Queen City Farms Vertical Barrier Wall System

**VERTICAL BARRIER WALL DESIGN
PROJECT CLOSURE REPORT**

**QUEEN CITY FARMS SUPERFUND SITE
MAPLE VALLEY, WASHINGTON**

APPENDIX B DESIGN AND SPECIFICATION MODIFICATIONS

STATION 13+79

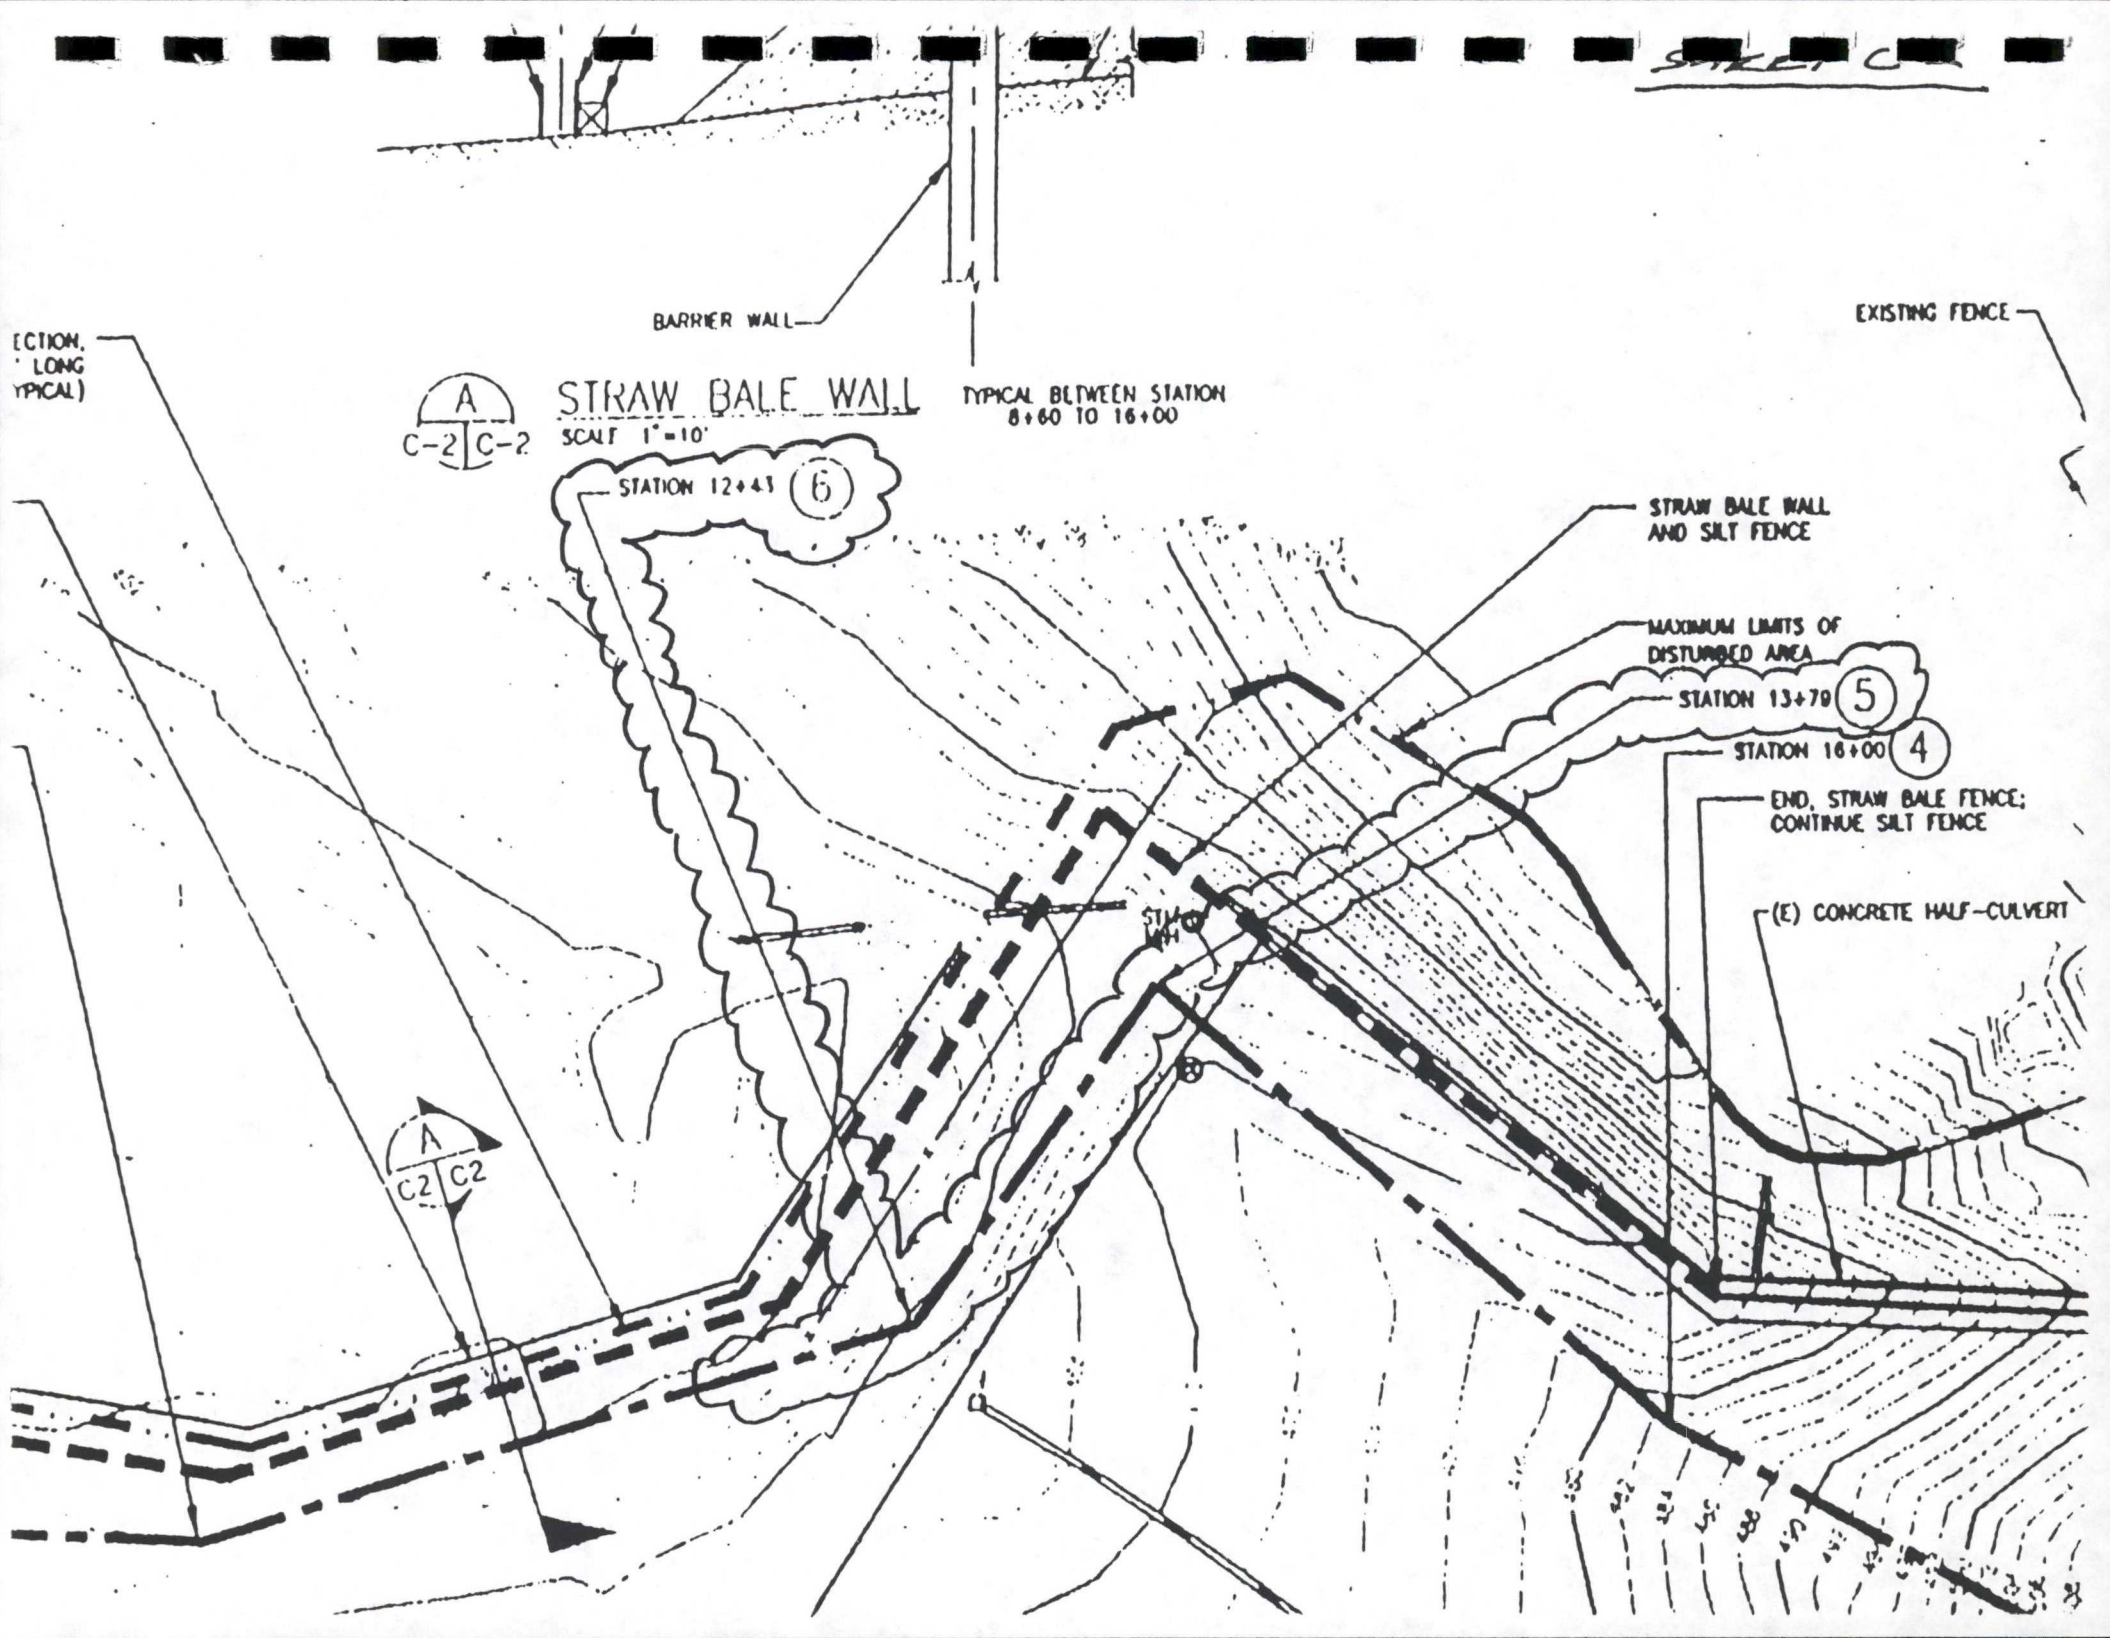
1. The barrier wall trench between Turning Point 5, Sta. 13+79, and Sta. 11+70, approximately, is being constructed along a curve instead of on the straight design centerline alignment indicated on sheet C-2. The curve enables the trench to be constructed continuously without having to stop to construct Turning Point 6, Sta. 12+43, using the typical turning point construction method. The curve is expected to reduce the time required to construct the barrier wall trench in the vicinity of Turning Point 6.

2. The curve alignment is located outside of the designed centerline alignment indicated on plan sheet C-2. Therefore the cap zone will not be reduced as a result of the trench realignment.

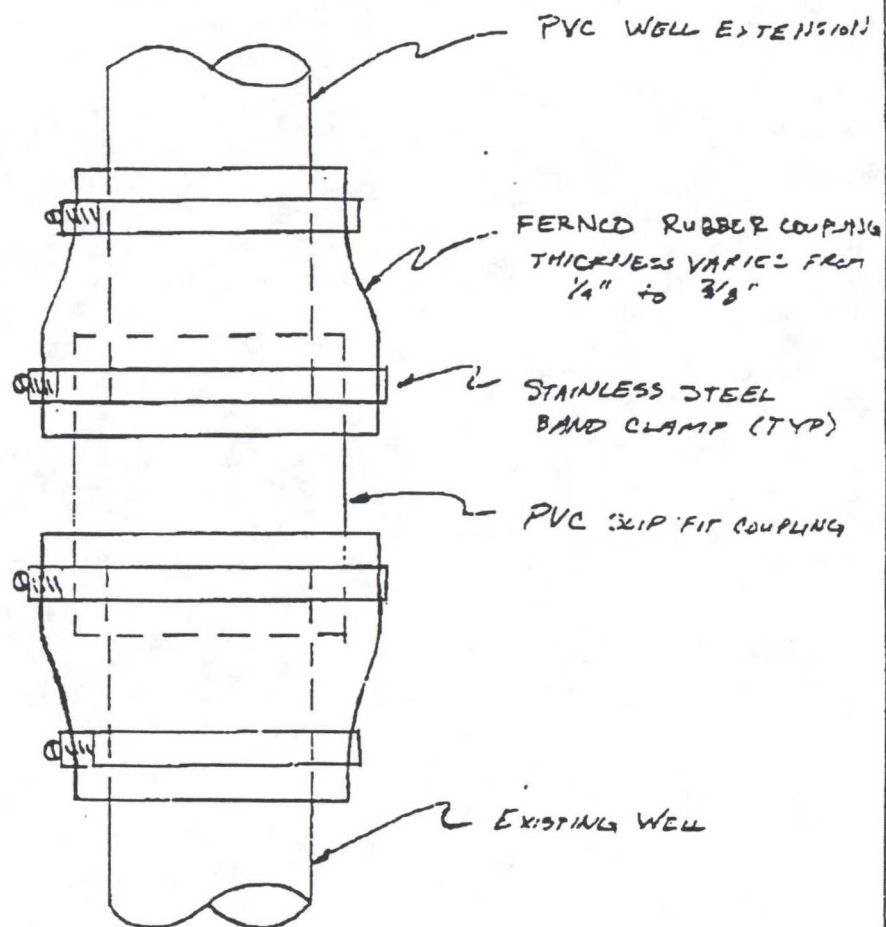
1. The attached is an acceptable alternative to the Monitoring Well Extension Detail depicted on sheet C-10. The two couplings indicated on the alternative detail perform the same function as the boot indicated on C-10, and provide a more convenient method for assembling the extension.
- B. Corrections or comments made on the Shop Drawings during this review do not relieve the Contractor from compliance with the requirements of the Drawings and Specifications. This check is only for review of general conformance with the design concept of the Project and general compliance with the information given in the Contract Documents. The Contractor is responsible for confirming and correlating all quantities and dimensions, selecting fabrication process and techniques of construction, coordinating their work with all other trades, and performing their work in a safe and satisfactory manner.
